DEVELOPMENT APPLICATION ASSESSMENT REPORT

Application Number:	DA2020/0126
----------------------------	-------------

Responsible Officer:	Catriona Shirley
Land to be developed (Address):	Lot 1 DP 555814, 173 Seaforth Crescent SEAFORTH NSW 2092
Proposed Development:	Alterations and additions to an existing dwelling house
Zoning:	Manly LEP2013 - Land zoned E3 Environmental Management
Development Permissible:	Yes
Existing Use Rights:	No
Consent Authority:	Northern Beaches Council
Delegation Level:	DDP
Land and Environment Court Action:	No
Owner:	Anthony Ng Joan Ng
Applicant:	Jayn Design

Figure 1: Building height variations shown in blue.

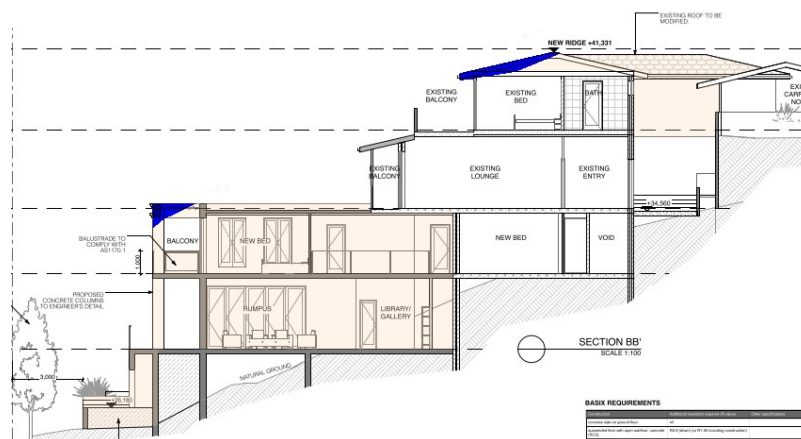
The development at the rear of the dwelling house is for a flat style roof form. This flat style roof design assists to minimise the overall height of the development such that only a minor area of roof form over the balcony area is over the 8.5m building height requirement.

The replacement of the roof form over the existing first floor development also demonstrates a variation to the 8.5m building height standard, however the roof line has been reduced from the existing RL41.46 to RL41.331 (reduction of 0.13m) due to a lowering in the pitch of the roofline. As a result, there are two minor areas of non-compliance with the building height demonstrated in Figure 1 & 2 below.

Figure 2: Maximum Building height measurements.

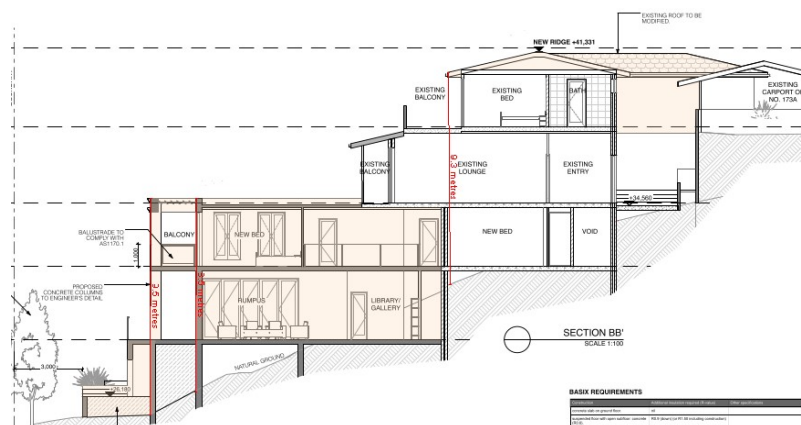
The proposals reduction in the building height closest to Seaforth Crescent and the flat roof design at the rear reflects the established built form character of the immediate Seaforth area where multi-level, and non-complying building heights are prevalent due to the steep topography of the land and difficulty with pedestrian and vehicular access.

Figure 4. Area of fill to create a level garden area at the rear of the site.

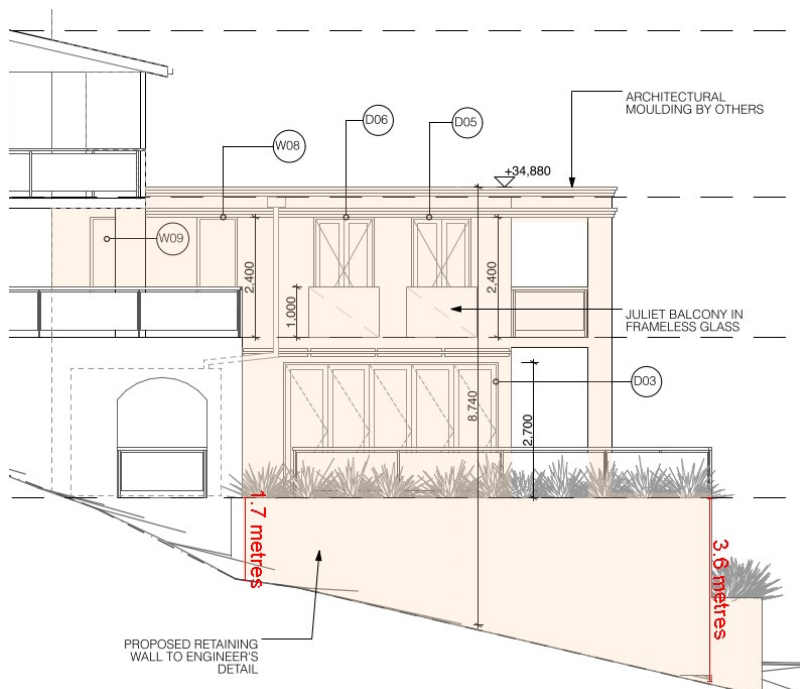
The Manly DCP 2013 permits a maximum fill of 1m. The proposal includes a fill of up to 3.6m for the landscaping at the rear of the site. See Figure 4 below.

Figure 5: Area of excavation for the library/gallery area.

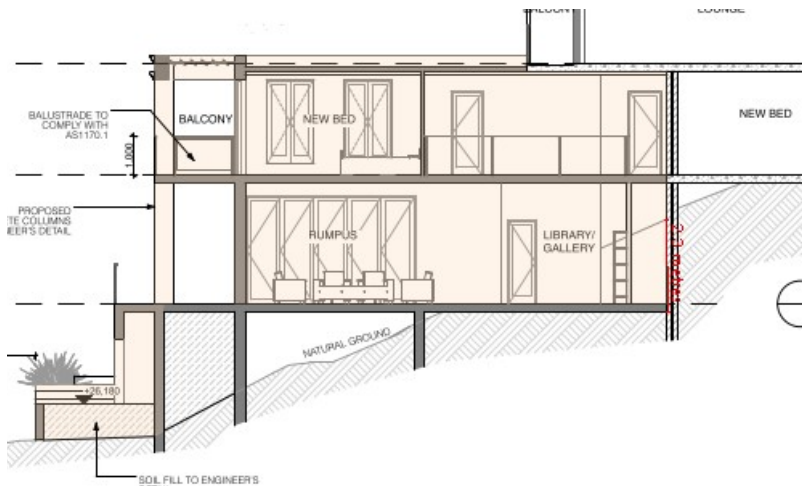
The DCP requires that excavation be generally limited to an area of 1.0m below natural ground level. Excavation is proposed to a depth of 2.5m at the rear of the lower floor plan. The subterranean area contains library/gallery area. The excavation is not within side boundary setback areas.

A Geotechnical Report has been submitted in support of the proposal. In the event of an approval, a condition of consent will require compliance with the recommendations contained in the Geotechnical Report.
